## Technical Tips - INSERT HEAD Module

### MaxiMailer – Service Engineers’ Technical Tips Documentation – Jan 2007

The following documentation describes all MaxiMailer field issues and corrective actions. Please refer to these documents before any service or maintenance is conducted. Items **highlighted thus** are Jan 2007 additions.

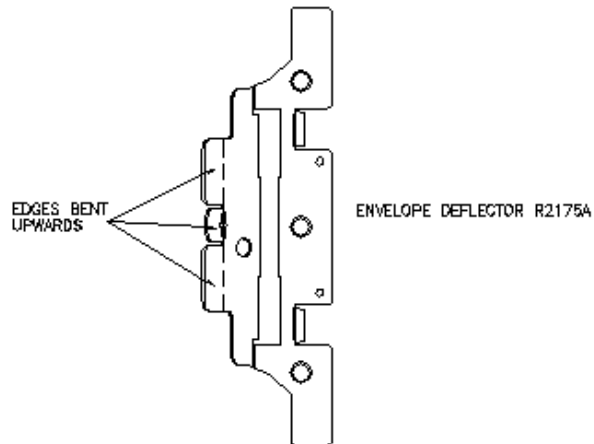
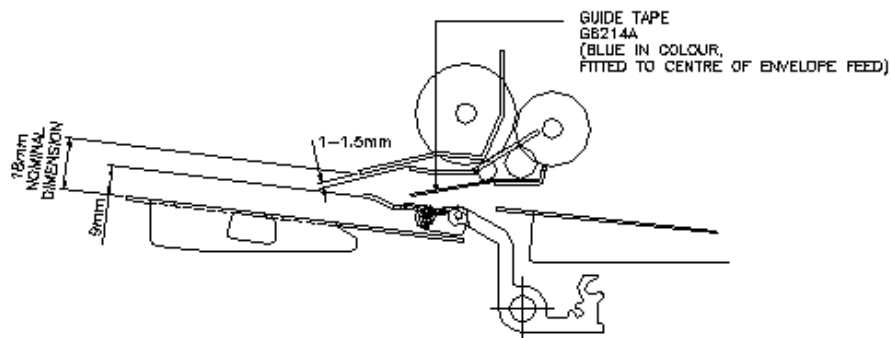
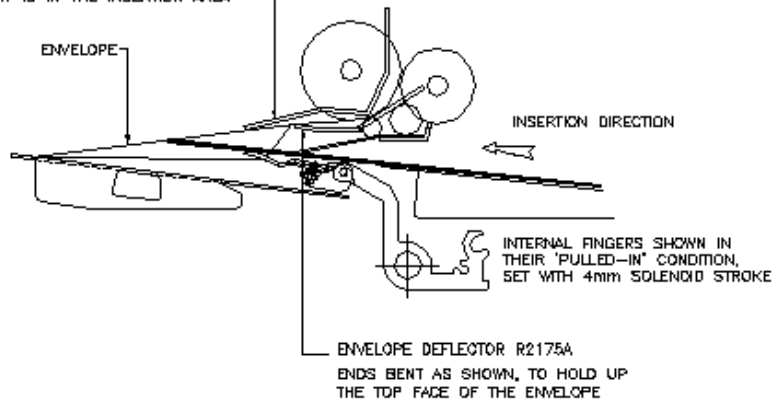
This tech tip can be implemented to provide additional opening (how much the envelope is popped) to the envelope whilst held in the stop position. The modifications consist of the following:-

5. Adjustable middle fingers set longer than standard. Ensuring that the envelope throat is held away from the inserts during insertion.

6. Additional guide tape (G6200A) added to the collate pocket clam assembly (A7060A). This is to give greater control on the inserts and prevent them from 'skewing' during insertion (and catching on the envelope side seams).
